RE: Chemsol, Inc. Superfund Site

RESPONSE TO USEPA, JANUARY 19, 2001 TECHNICAL REVIEW COMMENTS GROUNDWATER REMEDIAL WORK ELEMENT JUNE 2000, REMEDIAL DESIGN WORK PLAN CHEMSOL, INC. SITE

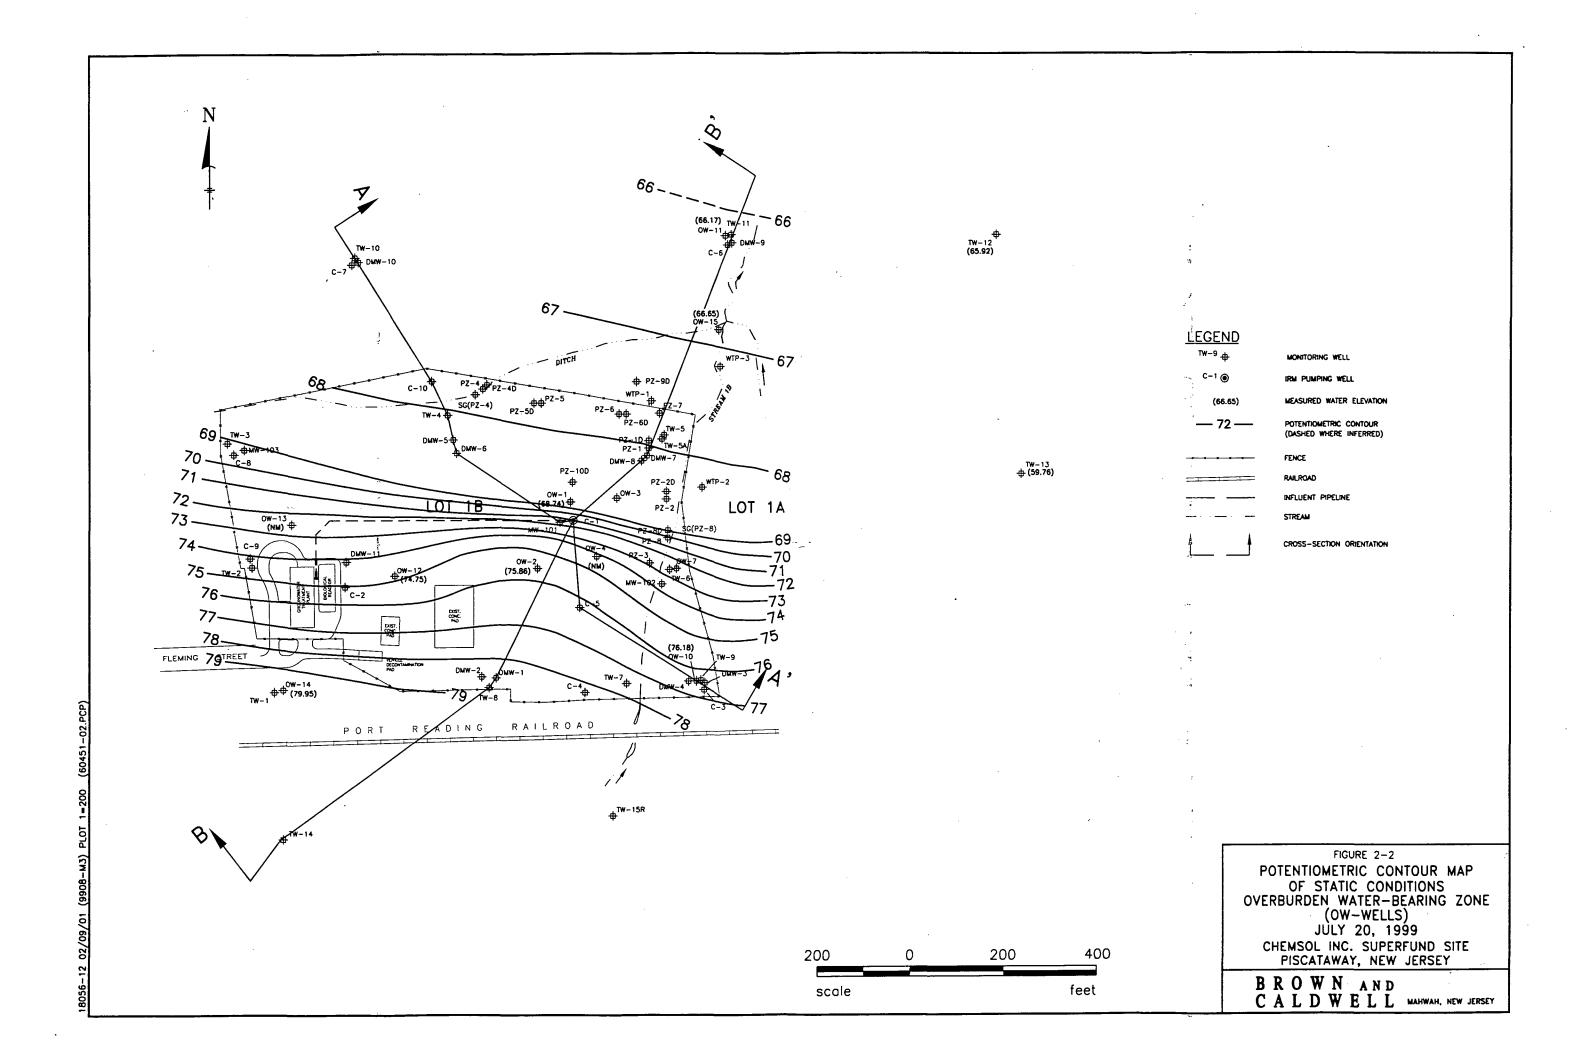
W-6 Page 2-5, Section 2.2.1, Conceptual Hydrostratigraphic Model. The second layer is referred to as the Upper Bedrock Aquitard in Figure 2-1. The change requested by EPA was made in the text but not in the figure.

EPA had requested that the overburden zone and the wells screened in this unit should be incorporated into Figure 2-1. This was not done.

This was an oversight and will be corrected in the revised RDWP.

At the scale of Figure 2-1, the overburden and overburden wells would not be discernable. It was agreed, therefore, that Figure 2-1 is adequate as is.

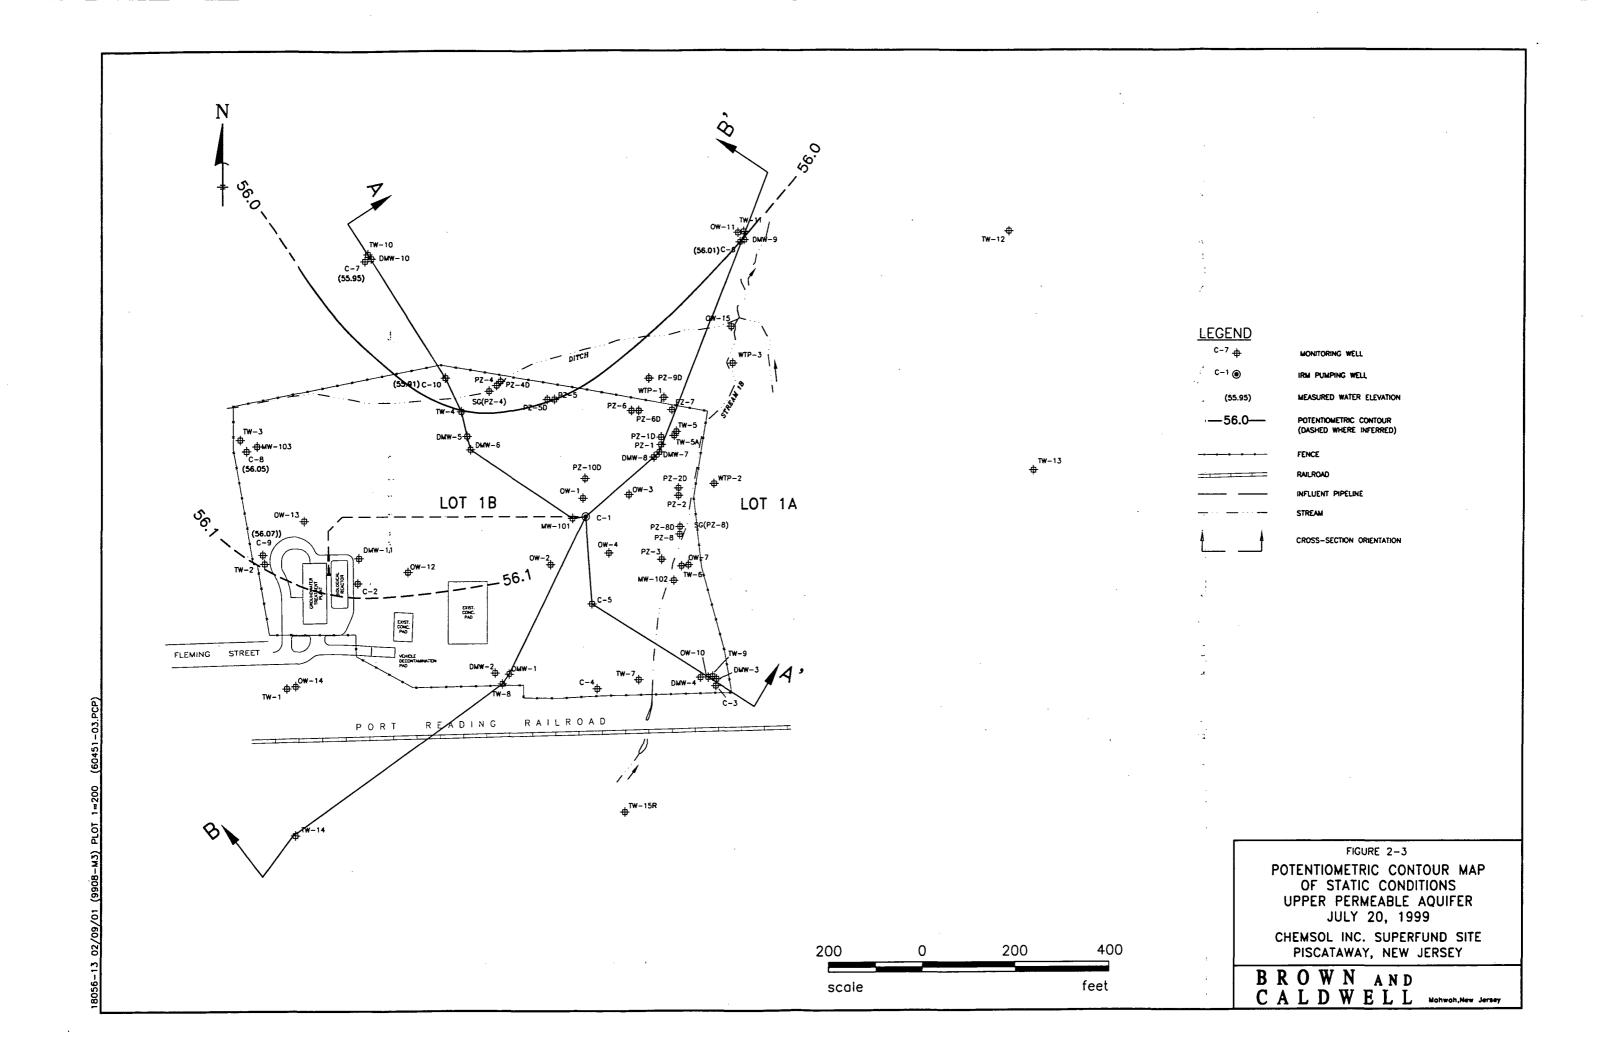
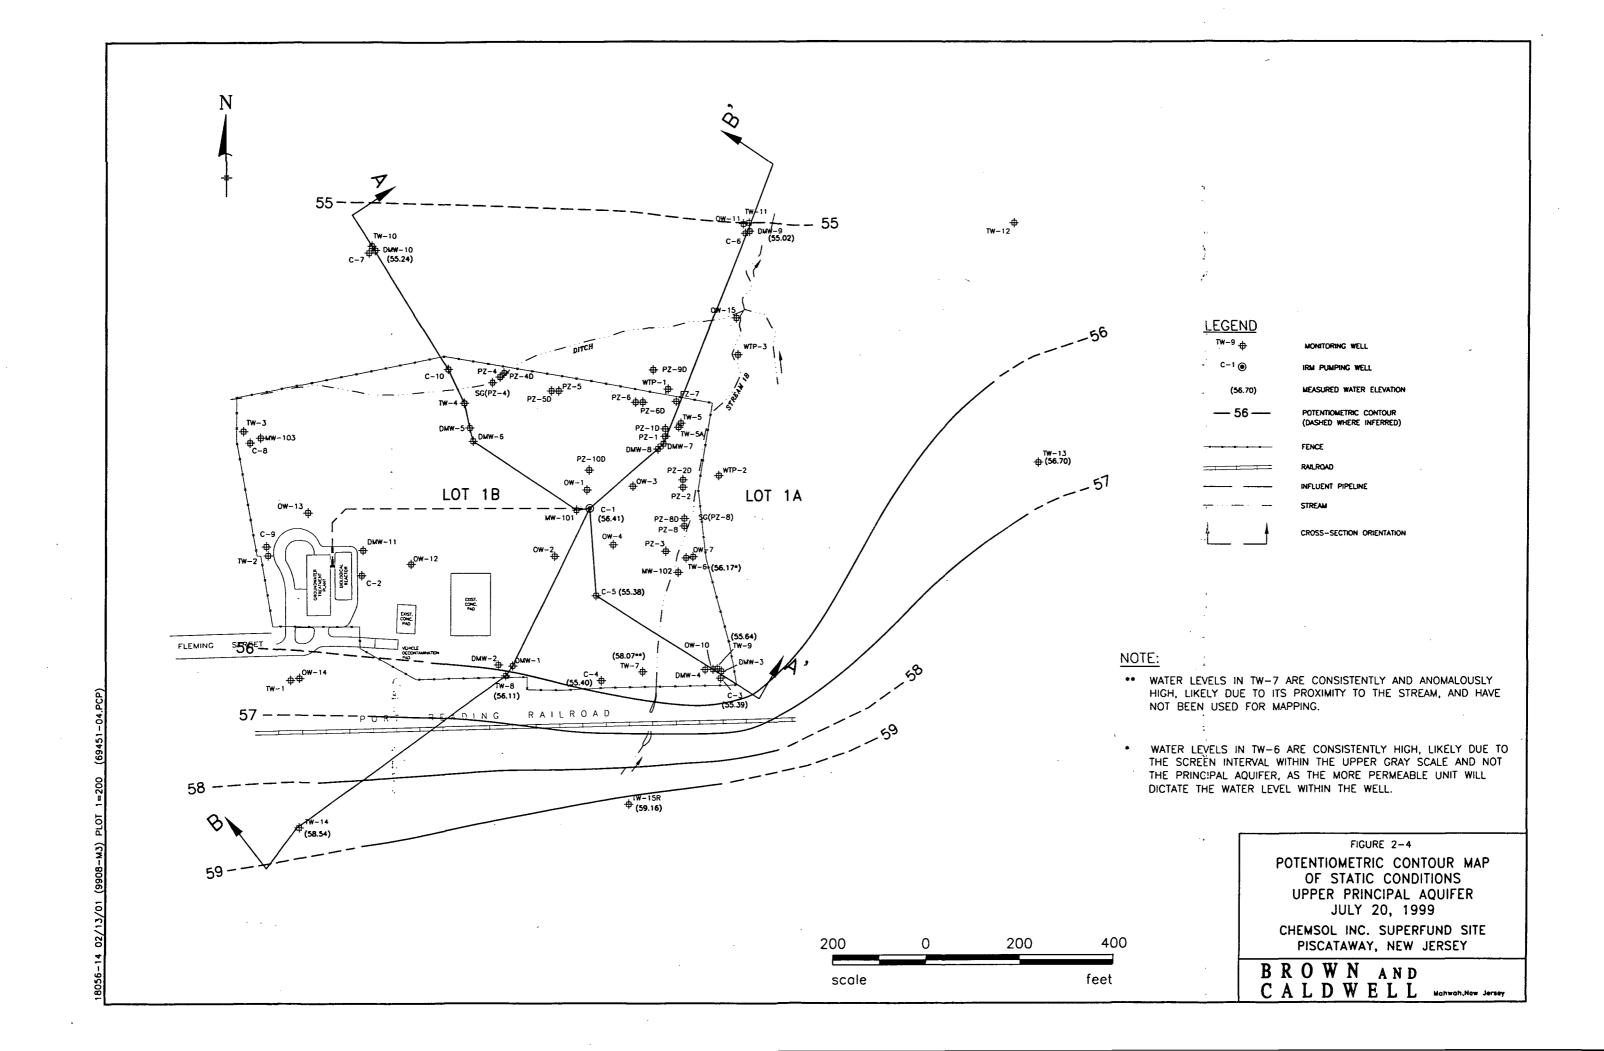
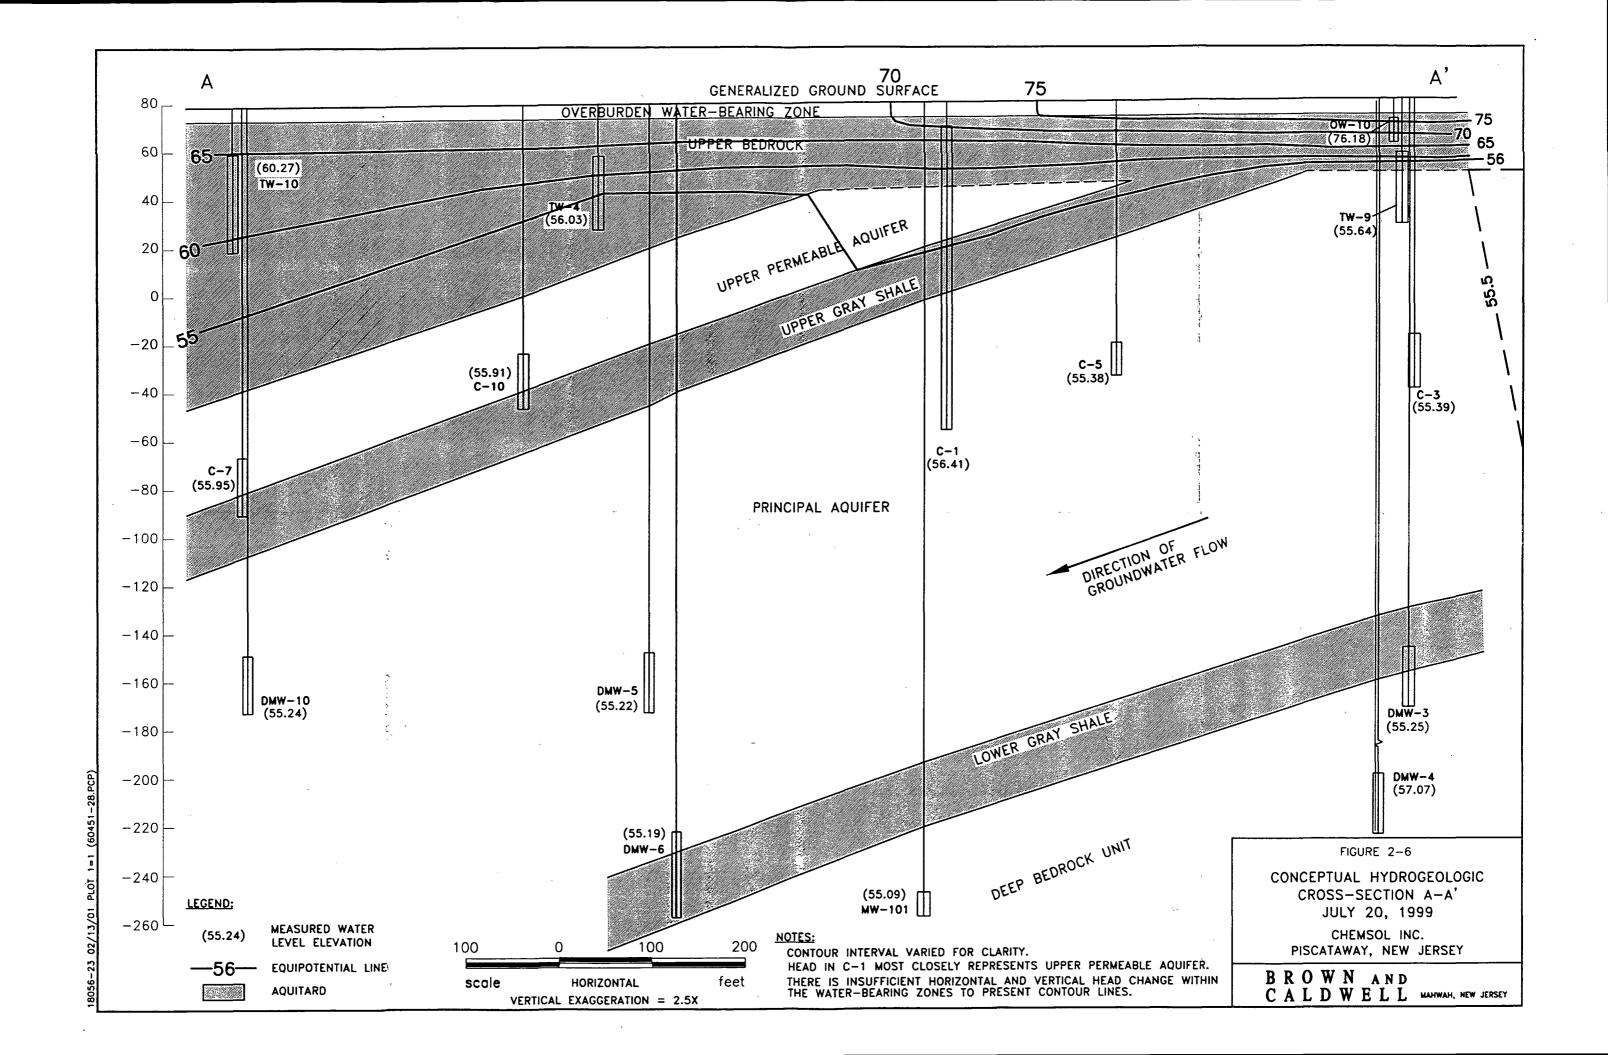
W-7 Figures 2-2 through 2-5 (Plan-view potentiometric contour maps). Please note that the potentiometric gradients at the site in the various hydrostratigraphic units are essentially flat and, therefore, easily influenced by potential off-site pumping. Contaminant migration across site boundaries can potentially occur at other locations besides the northern site boundary with the apartment complex.

As agreed at the January 23 meeting, no response is required for this item. A meeting with USEPA was held at the site on December 18, 2000 to discuss hydraulic gradients at the site and the implications to the design of the groundwater extraction system. The USEPA expressed concern that the flat gradients, as noted in this comment, P:\^J\20541\RDWP\usepa groundwater comments response chemsol rdwp.doc

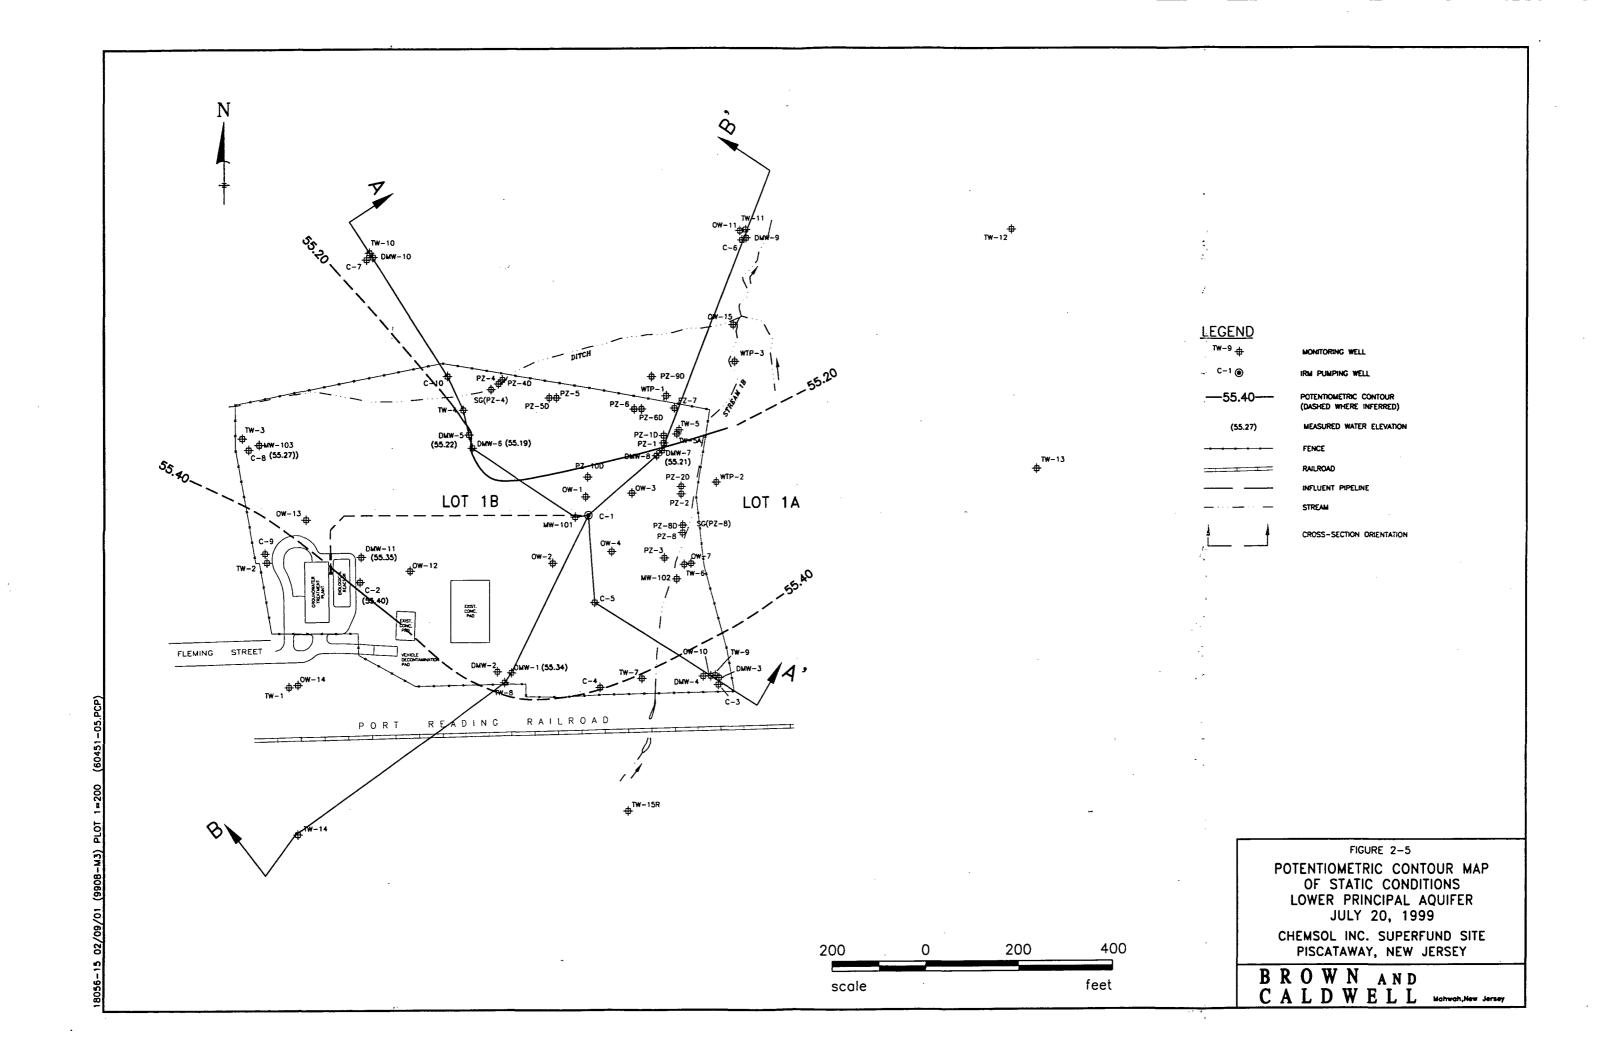
EPA had requested an explanation of why wells like TW-6, TW-8 and TW-14 which are screened across the Upper Gray Shale (Aquitard) were included in the potentiometric contour map for the Upper Principal Aquifer (Figure 2-4). This explanation was not provided.

The explanation was provided on Figure 2-4 under the Note. This explanation will be expanded to note that the upper principal aquifer will have the greatest influence on water level and thus these wells, screened across both the Upper Gray Shale and the Upper Principal A quifer, were considered representative of the Upper Principal A quifer.
